Product Change Notification

PCN #: 20250108-02

Change Title: Optimization of internal structures of the AZEV116 and AZEV132 series.

Products Affected: AZEV116, AZEV132 series relays.

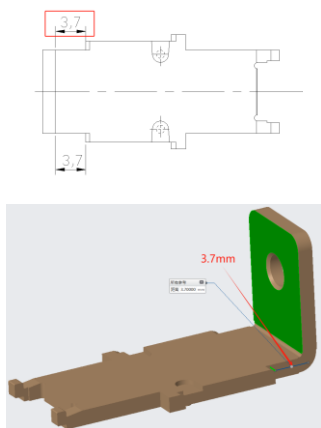
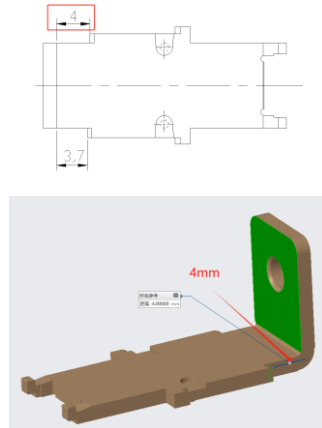
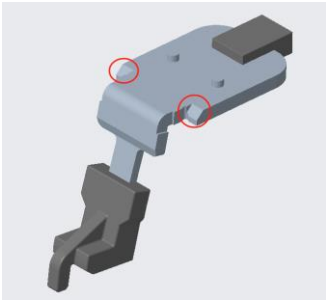
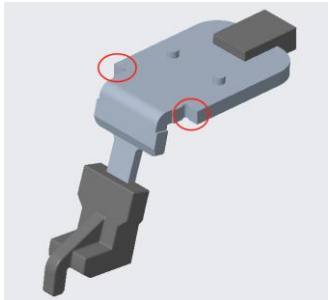
1. Modifications of internal structures (yoke, armature subassembly) to optimize assembly processes at automated production lines.
2. Plastic material changes at armature subassembly for increased temperature resistance.

Item	Before	After
Yoke: increase cutout dimension		
Yoke: decrease height of hooks

Armature subassembly: omit beveled edges		
Armature subassembly: change from PPS to LCP material
